SERVICE BULLETIN

SERVICE BULLETIN No. 090

Alternator Thru-Bolts

Figure 1 - Thru-Bolt Locations

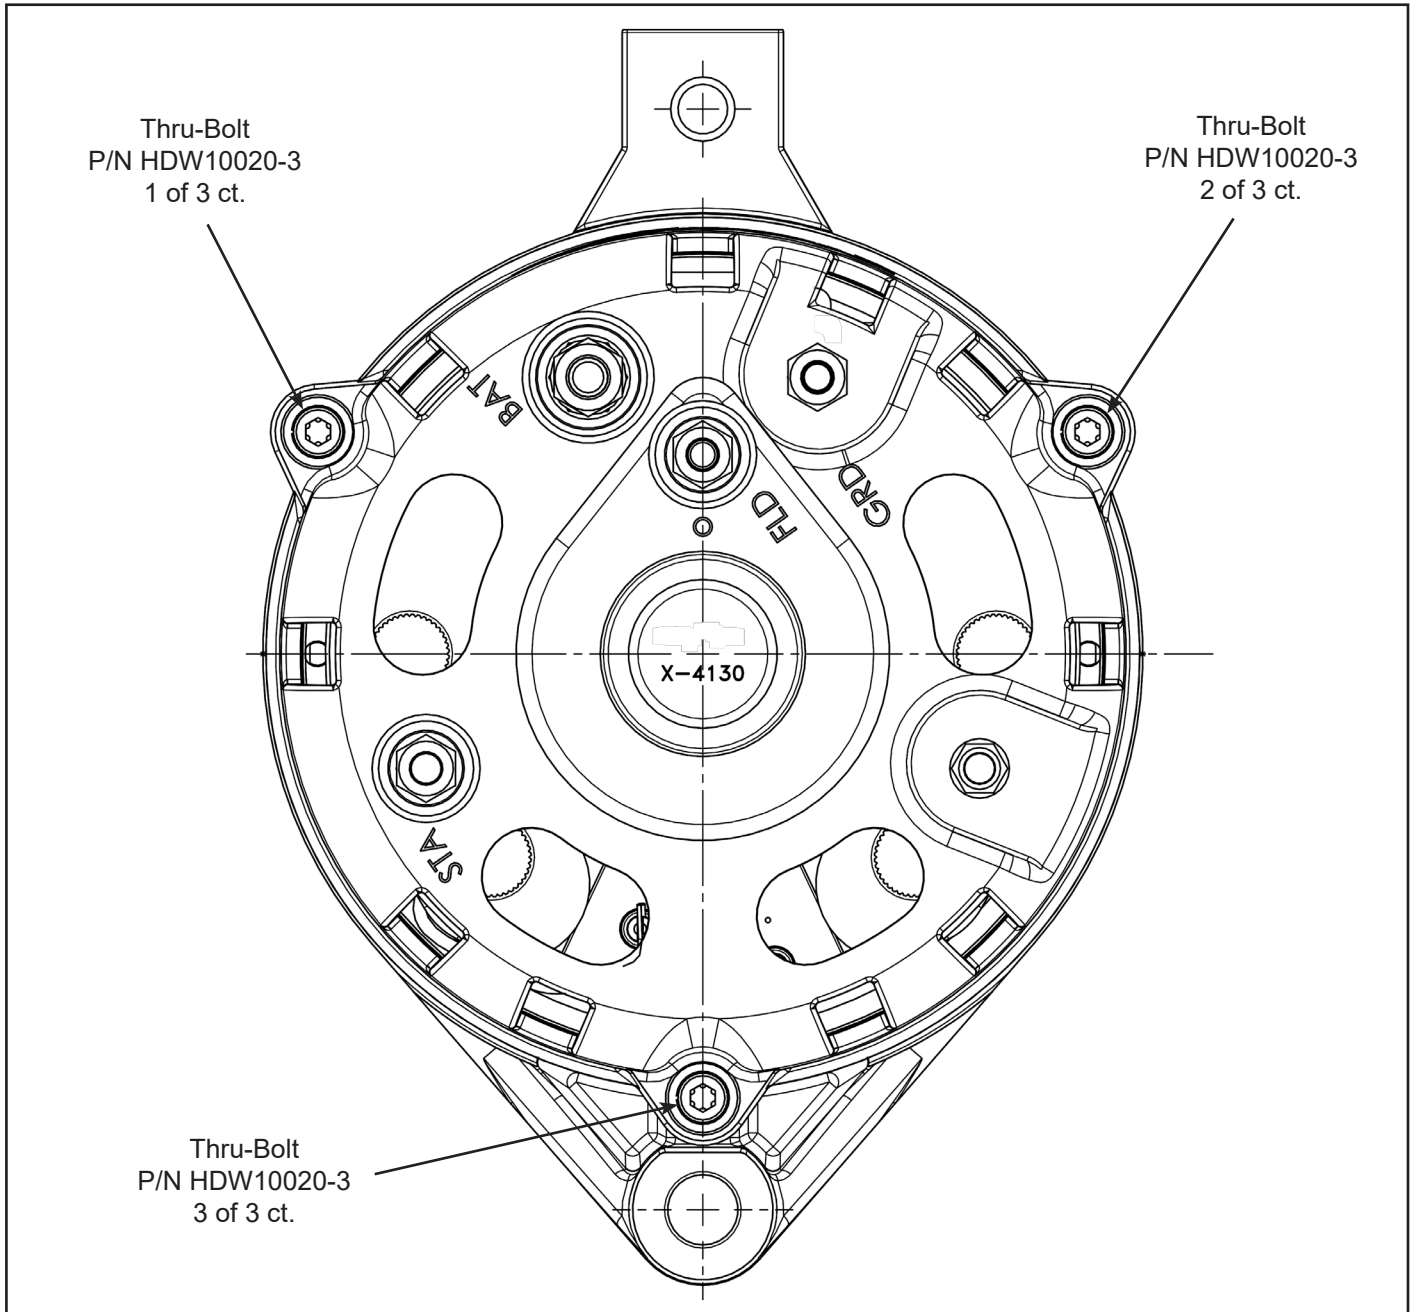
- (a) Gain access to the alternator in accordance with the latest revision of the aircraft and/or engine maintenance manual.
- (b) Visually inspect the three (3) thru-bolts (Fig.1) for evidence of cracks, broken safety-cable/wire, and/or sheared bolt heads. If indications are present, proceed to 3.B.2 and replace the alternator prior to further flight.
 - 1) If no cracks, broken safety cable/wire, or sheared thru-bolt heads are present, perform a recurring inspection every 25 aircraft-hours not to exceed one-hundred aircraft-hours from the initial inspection.
 - 2) At an accumulated one-hundred aircraft-hours or at the next scheduled annual aircraft inspection, whichever occurs first, the alternator must be replaced. See **Option 2**.

- (a) Remove the alternator from the engine in accordance with the latest revision of the aircraft and/or engine manufacturer's maintenance manual.
- (b) Install a new, overhauled, or repaired alternator in accordance with applicable engine manufacturer's maintenance manual. Refer to 2.A, Materials Required.
- (c) Reconnect alternator electrical connections and cooling hardware in accordance with applicable aircraft manufacturer's maintenance manual. Continue to 3.C. Return to Service.
